ADA Curb Ramp New Construction Inspection Form (Parallel)

NW Timeric

23885.56

NW North

PARALLEL RAMP (PL)

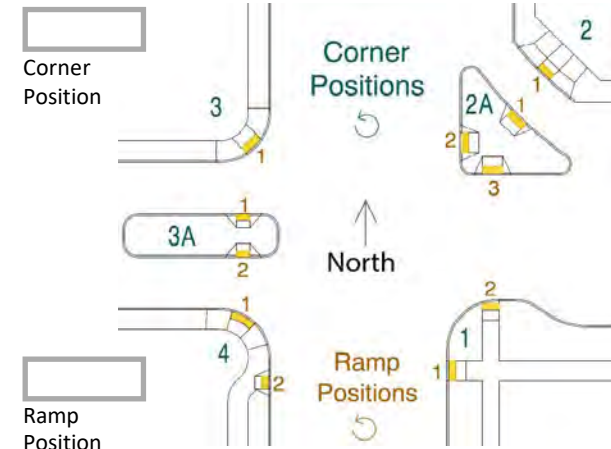
4.3 $\leq *$ ☐ $> *$ ☒

5.6 $\leq |5.0\%|$ ☒ $> |5.0\%|$ ☐

7.3 $\leq 2.0\%$ ☐ $> 2.0\%$ ☒

9.7 $\leq 2.0\%$ ☐ $> 2.0\%$ ☒

Comments:
NTD RR1 TS Fail
